7.0 Instrumentation and Control Systems

7.1 Introduction

The information in this section of the reference ABWR DCD, including all subsections and tables, and figures, is incorporated by reference with the following departures and supplements.

Figure 7.1-1 ~~SSLC Self-Test System~~ SSLC Self-Test System Diagnosis

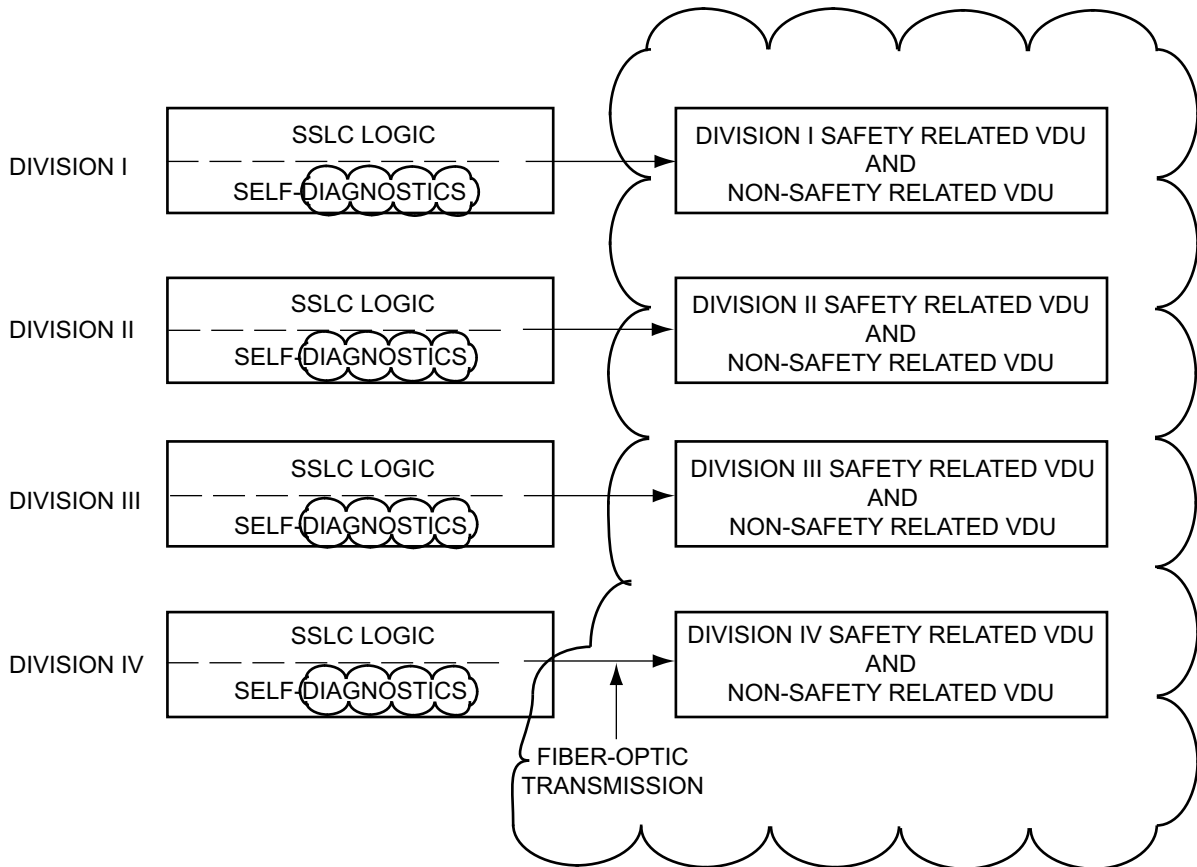
STD DEP T1 3.4-1 (Figure 7.1-1, 7.1-2)

STD DEP T1 3.4-1

Each individual safety-related system utilizes redundant channels of safety-related instruments for initiating safety action. The automatic decision making and trip logic functions associated with the safety action of several safety-related nuclear steam supply systems (NSSS) are accomplished by ~~a four division correlated and separated protection logic complex called the~~ safety system logic and control (SSLC). The SSLC includes multiple redundant divisions, which are separated from each other. The SSLC has four redundant divisions of sensors. Each division of sensors has a corresponding division that determines the trip status of the safety functions relative to the safety function setpoint. The SSLC has four redundant divisions for all actuation functions except for the engineered safety features. The engineered safety features have three divisions, corresponding to the maximum redundancy of the engineered safety features actuated components. Some engineered safety features functions are less than three-fold redundant and are assigned to the appropriate set of redundant divisions. The SSLC multi-divisional complex includes divisionally separate control room and other panels which house the SSLC equipment for controlling the various safety function actuation devices. The SSLC receives input signals from the redundant

The ~~RPS RTIS and ESFELCS~~ Systems can be tested during reactor operation ~~by six separate tests~~. The first five tests are primarily manual tests and, although each individually is a partial test, combined with the sixth test they constitute a complete system test. The sixth test is the ~~self~~ test of the safety system logic and control which ~~automatically~~ tests the complete system excluding sensors and actuators.

Figure 7.1-2 Assignment of Interfacing Safety System Logic to SSLC Controllers

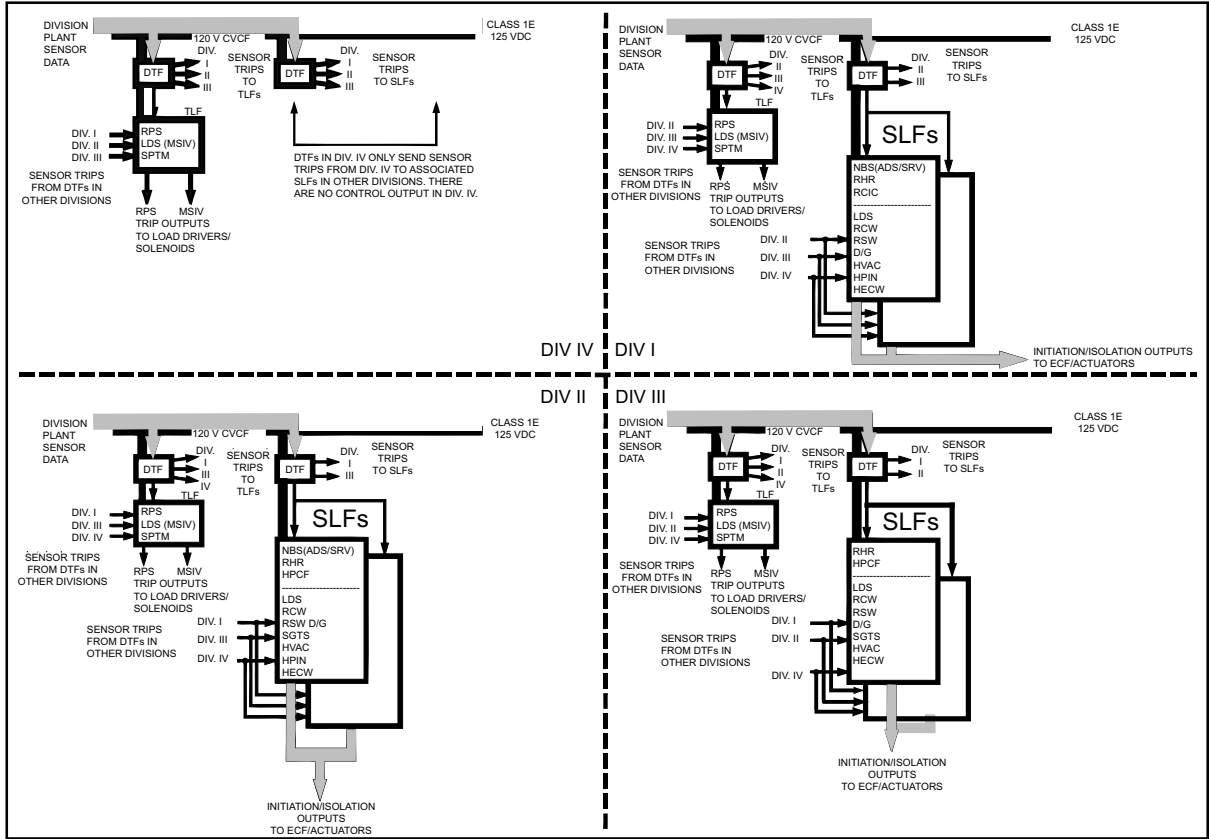
~~Divisional separation is also applied to the essential multiplexing system (EMS), which provides data highways for the sensor input to the logic units and for the logic output to the system actuators (actuated devices such as pump motors and motor-operated valves).~~ Systems which utilize the SSLC are include: (1) Reactor Protection (trip) System; (2) High Pressure Core Flooder System; (3) Residual Heat Removal System; (4) Automatic Depressurization System; (5) Leak Detection and Isolation System; (6) Suppression Pool Temperature Monitoring System; and (7) Reactor Core Isolation Cooling System. The equipment arrangement for these systems and other supporting systems is shown in Figure 7.1-2.
